RIOCAN – WINDFIELDS FARM BLOCK C2: RFP – ADDENDUM NO.03

ADDENDUM NO.3 ISSUED: August 1st, 2023

Project Name:	Windfields Block C2	Date:	2023-08-01
Address:	Winchester Road & Simcoe Street, Oshawa, ON	Addendum No.:	03
		Proj. No.:	08.118CS3

Project Name:	Windfield Farms Block C	Issued Date:	August 1, 2023
Project Address:	WINCHESTER ROAD & SIMCOE STREET OSHAWA, ONTARIO	M ADD No.:	2
Issued By:	Rishard Ragoonanan Dan Joffe	Architect:	Turner Fleischer
Project No.:	22-000-176	Attention:	Edward Uzoma

PROJECT NO. 08.118CS3	
PROJECT DATE 2022-07-08	
DRAWN BY MHB	
CHECKED BY ECU	
SCALE AS NOTED	
DRAWING NO. A002

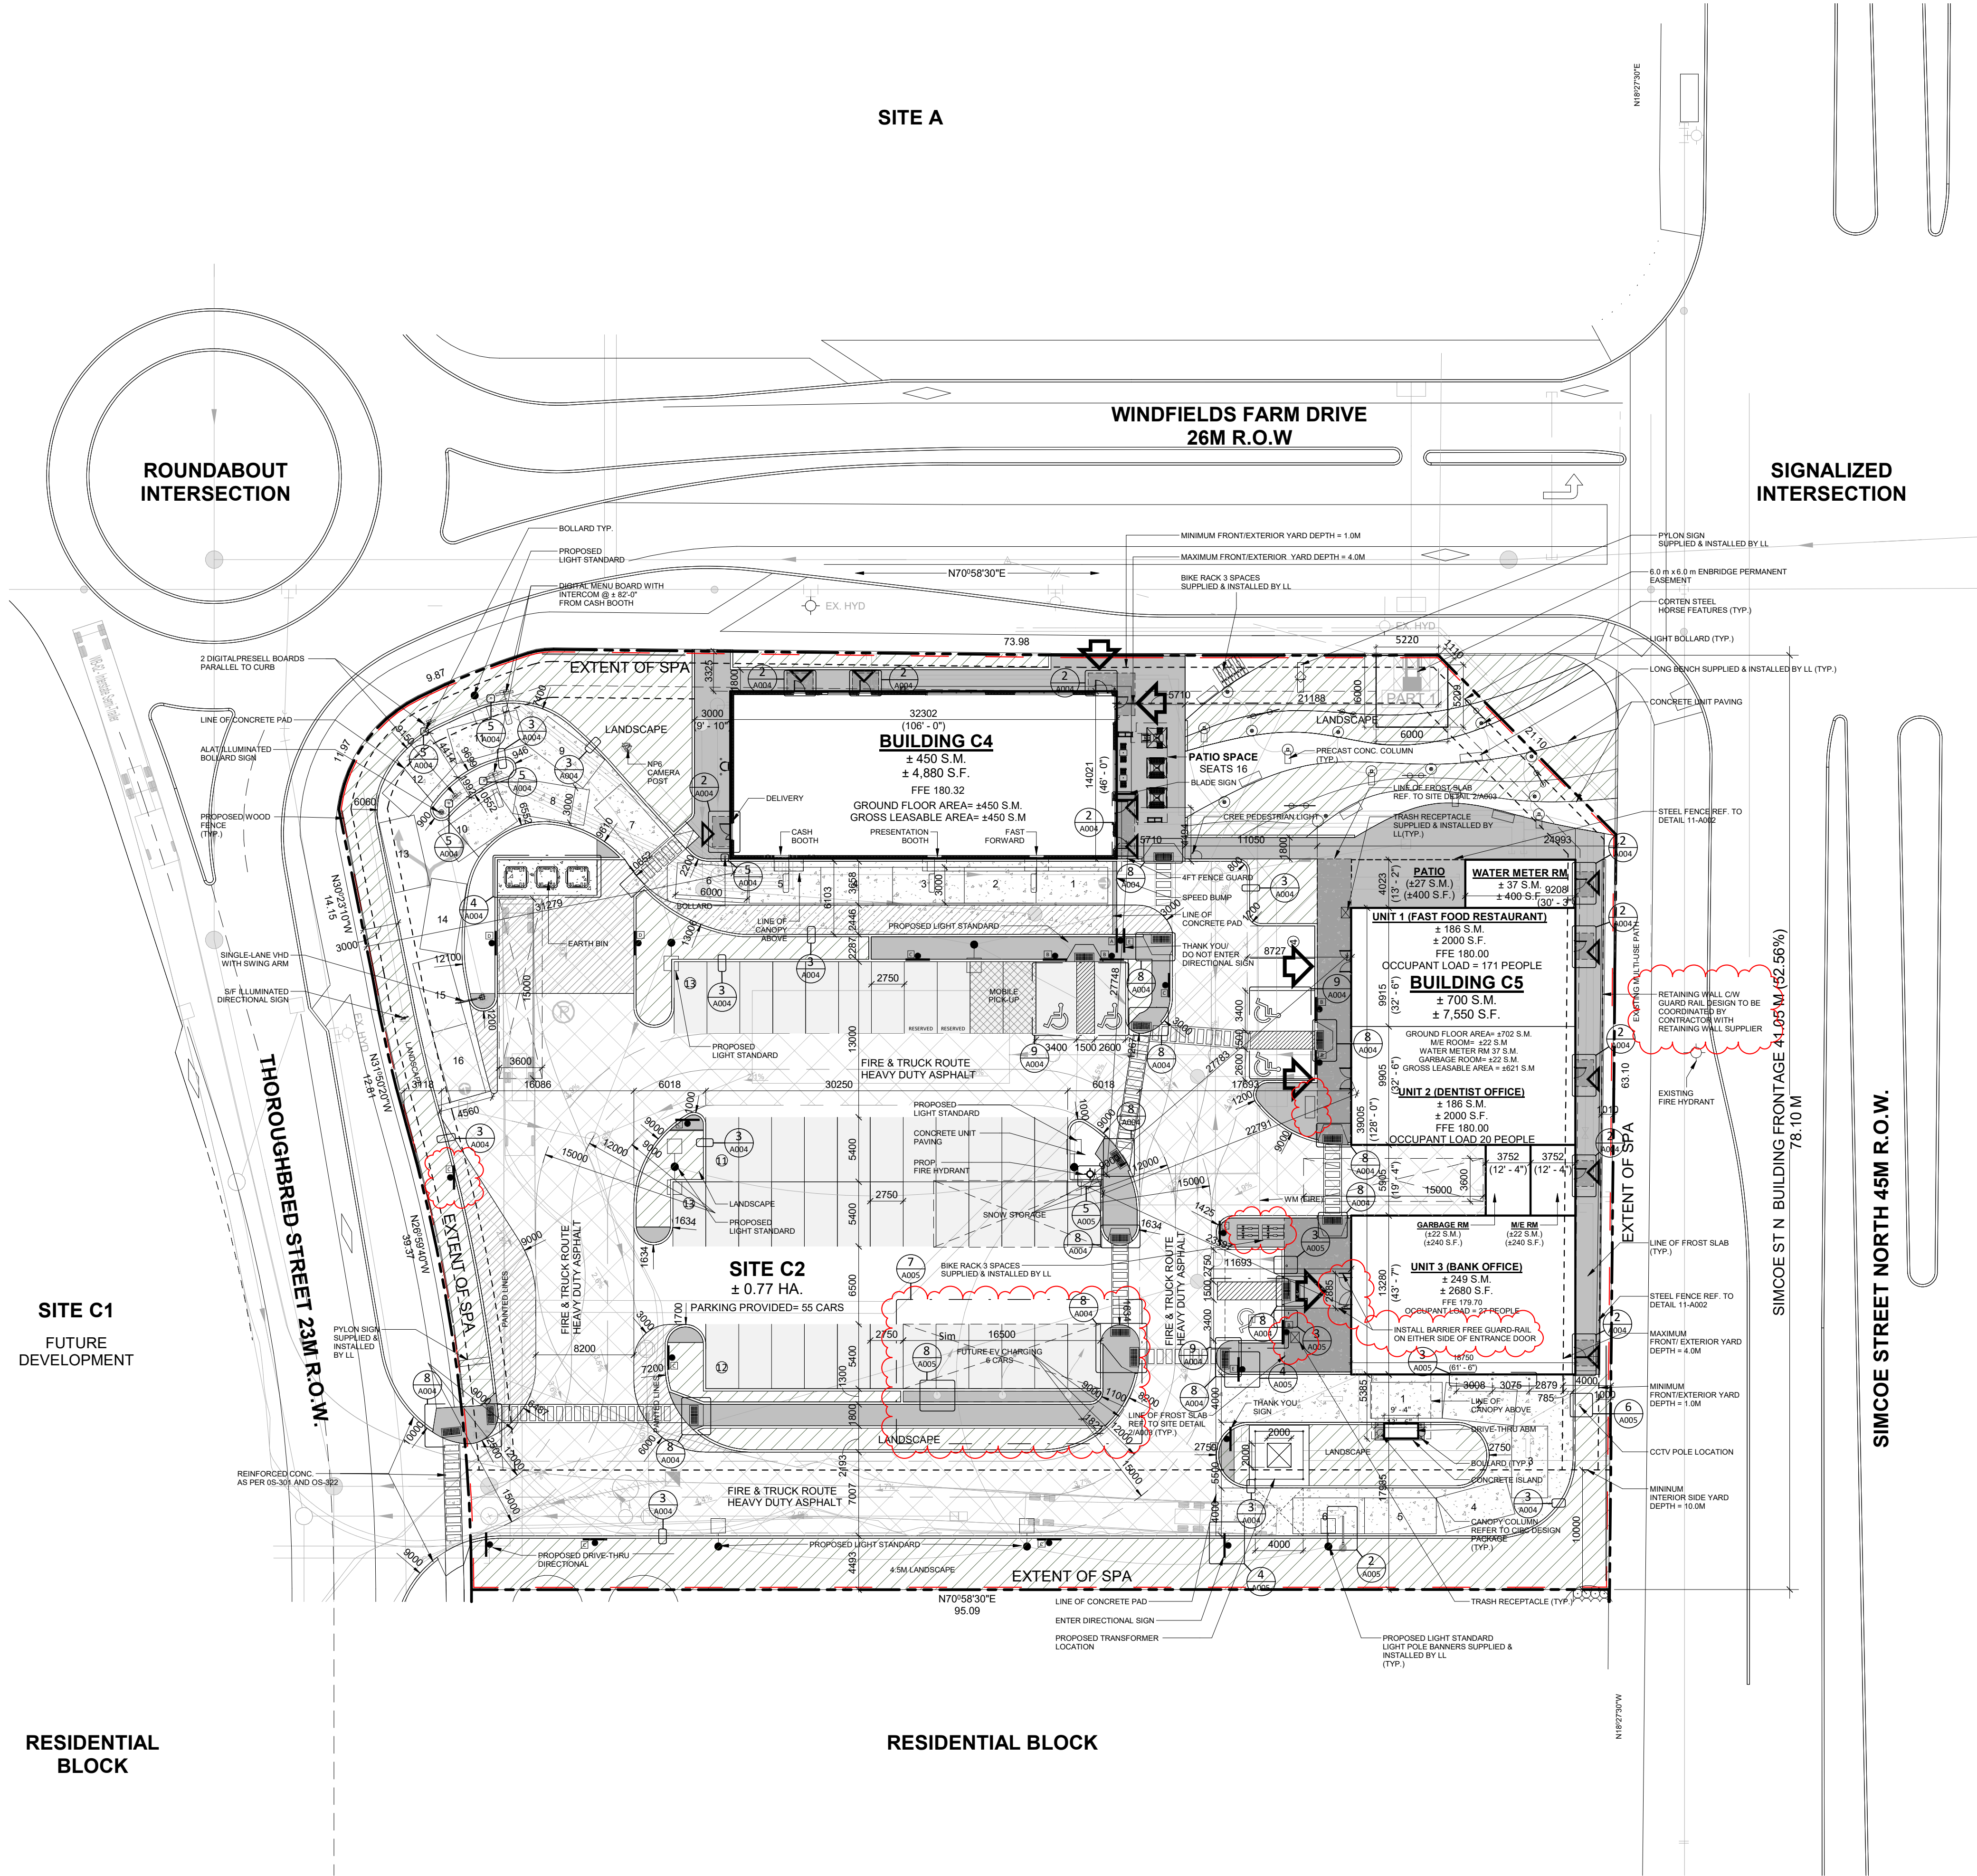
- 1.03 Revise Drawing A002 – Site Plan, and A005 – EV Charging Station Base details**
- a) Relocation of signage, bollards and site furniture (i.e, bicycle rack, bench, and trash receptacles). See attached.
 - b) Revised note for retaining wall. See attached.
 - c) Revised note for Barrier- Free Guard-rail at Unit 3 (CIBC). See attached.
- Revise drawing A005 – Site Details**
- d) EV Charging Station Callout and details added. See attached.
- Revise drawing A301 - Elevations**
- e) Added additional wall sconce to West Elevation 1/A301. See attached.
